HISTORIC LANDMARK COMMISSION STAFF REPORT

Fournier Porch Railing Minor Alterations Case PLNHLC2012-00080 153 North C Street May 17, 2012

Exhibit A:
Proposed Plans

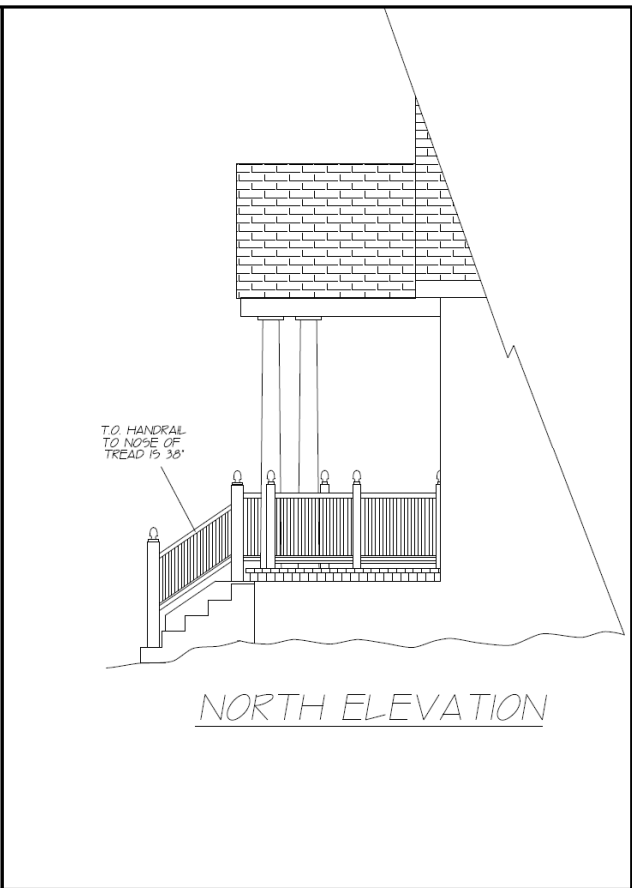
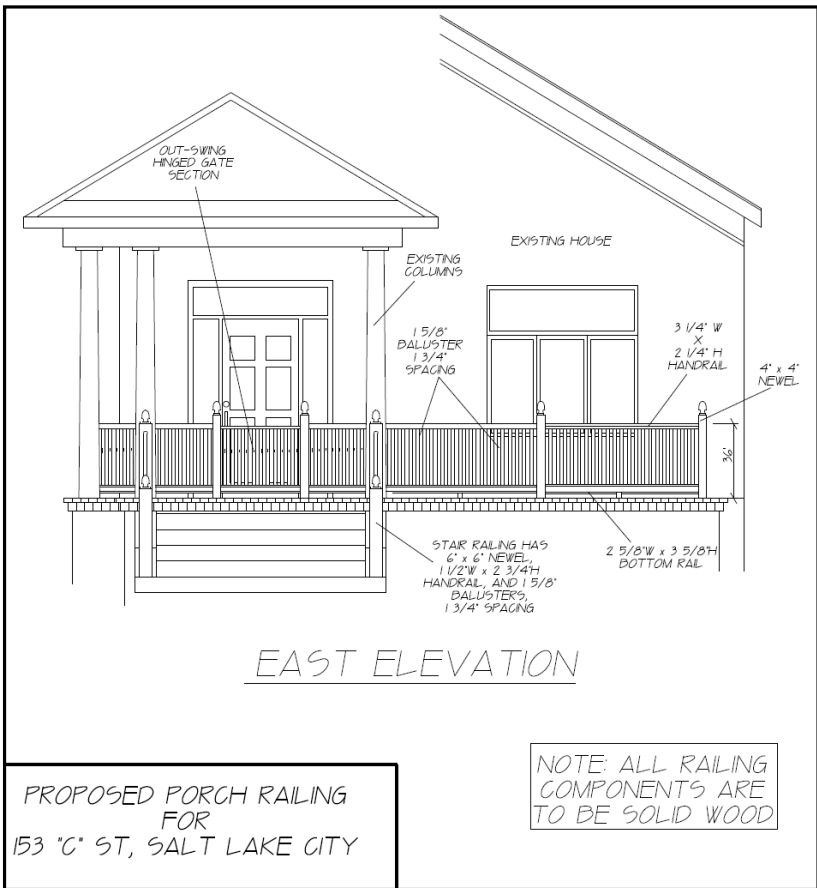
Analysis: The proposed railing will partially obscure views of the doorway from the public way. Staff has recommended that the railing be continued to the bottom of the stairs and the hinged gate be installed at grade in order to retain the view of the entry. Additionally, Greek Revival entryways traditionally do not include railing between columns.

Finding: While providing a wooden porch railing would not significantly alter the character of the home, allowing the railing to extend across the entryway would significantly change the intended character and view of the home. The project as proposed is not consistent with this standard.

- 1- That the gate and railing be moved to the bottom of the steps in order to retain the view of the historic entryway.
